# Preparation Support for Lelystad Airport Consultation

Report for LVNL

<b>Document title</b>	Preparation Support for Lelystad Airport Consultation Report for LVNL
<b>Author</b>	Helios
<b>Produced by</b>	Helios 29 Hercules Way Aerospace Boulevard - AeroPark Farnborough Hampshire GU14 6UU
<b>Produced for</b>	LVNL
<b>Helios contact</b>	Alan Corner Tel: +44 1252 451 651 Fax: +44 1252 451 652 Email: Alan.Corner@askhelios.com
<b>Version</b>	V1.0
<b>Date of release</b>	06 September 2017
<b>Document reference</b>	P2386D009

**Figure 6: Lelystad Airport TMA**

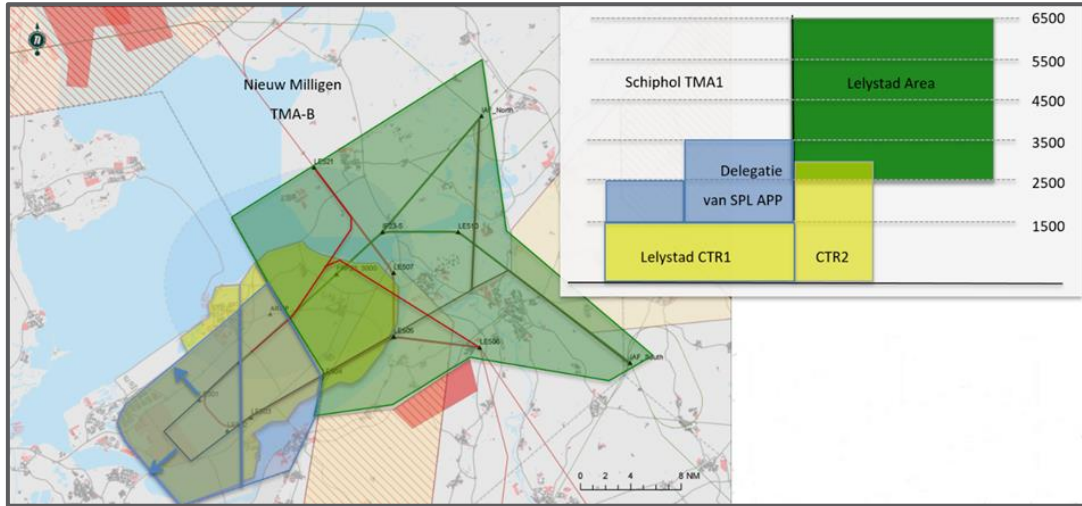
Evidently, the Lelystad airport TMA design appears to show adequate lateral containment of the Conops B+ arrival and departure routes.

**Figure 7: Vertical profiles of the arrival (green) and departure procedures (red) for Runway 05**

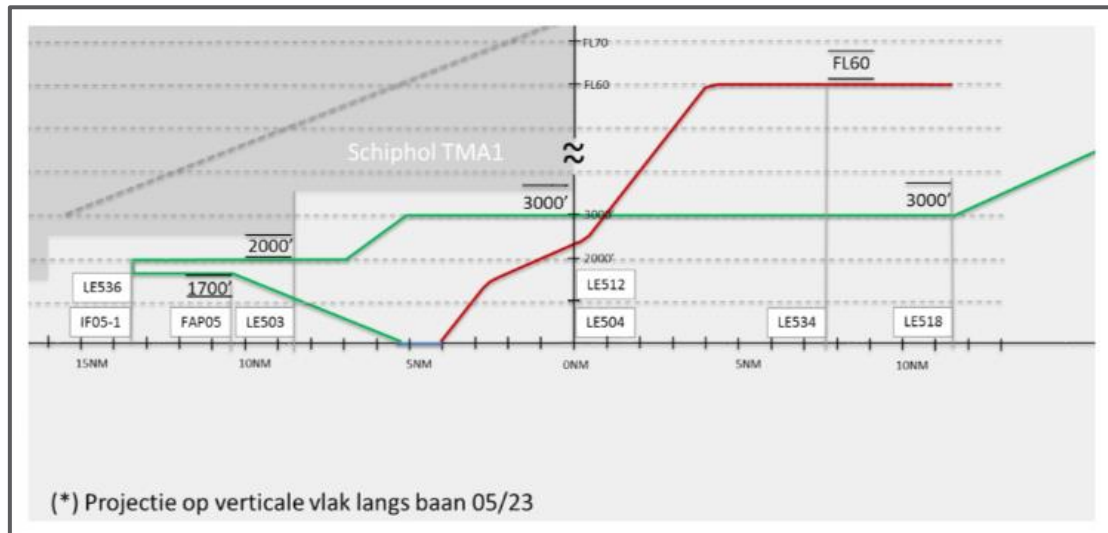
The departure procedures are shown climbing from threshold elevation to FL060 (approx. 6000ft) over a distance of approximately 11.5 NM (to waypoint LE534); this equates to a PDG of circa 8.5%. Whereas, the arrival procedure involves a series of shallow stepped descents culminating in a final uninterrupted descent from an altitude of 1700ft to threshold over a distance of approximately 6 miles; this equates to a descent gradient of circa 5.2% (3 degrees). All conceptual design gradients therefore fall within PANS OPS criteria.

**Figure 8: Vertical profiles of the arrival (green) and departure procedures (red) for Runway 23**

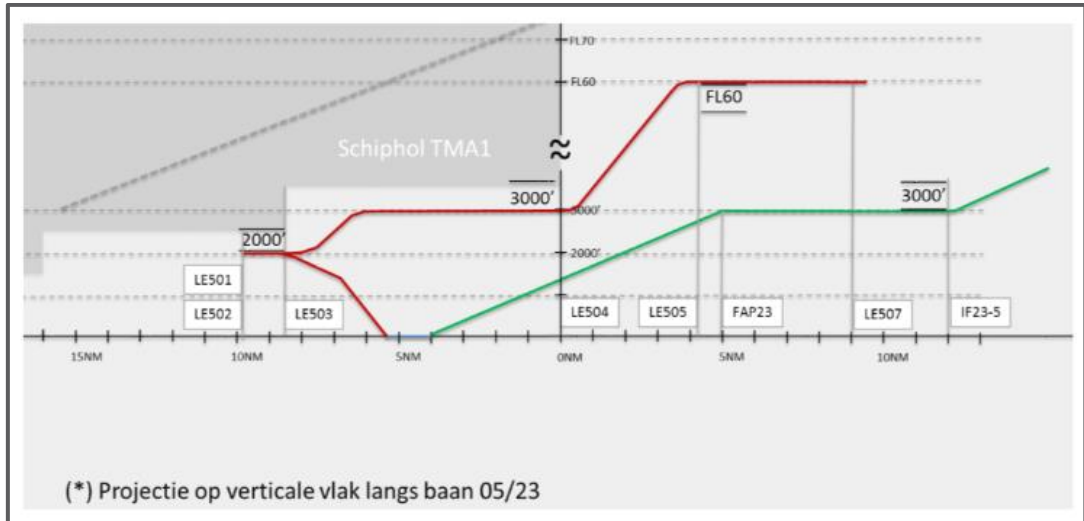
The departure procedures are shown with a series of interrupted climbing segments in order to keep departing aircraft within the stepped vertical limits of the TMA. The steepest portion involves a climb from altitude 3000ft to 6000ft over a distance of approximately 5 NM; this equates to a PDG of circa 9.9%. Whereas, the arrival procedure involves a series of shallow stepped descents culminating in a final uninterrupted descent from an altitude of 3000ft to threshold over a distance of approximately 8 NM; this equates to a descent gradient of circa 5.2% (3 degrees). All conceptual design gradients fall within PANS OPS criteria.

**Figure 9: Vertical cross section of Lelystad TMA**

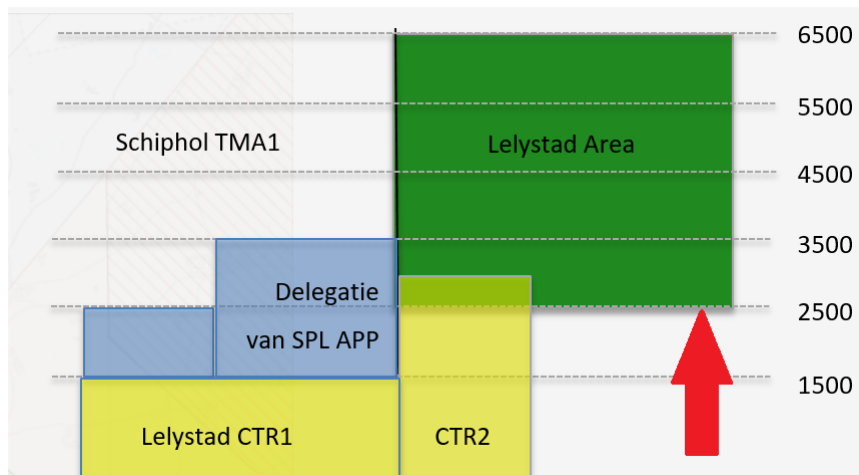
We note that whilst the Lelystad TMA achieves vertical containment of the Conops B+ routes, the base level of the Lelystad airport TMA in the vicinity of the Initial Approach Fixes at 2,500ft (as shown below in Figure 9) seems unnecessarily low, when the stated requirement is for inbounds to maintain a minimum of FL060 and to descend to 3,000ft 'as late as possible'.
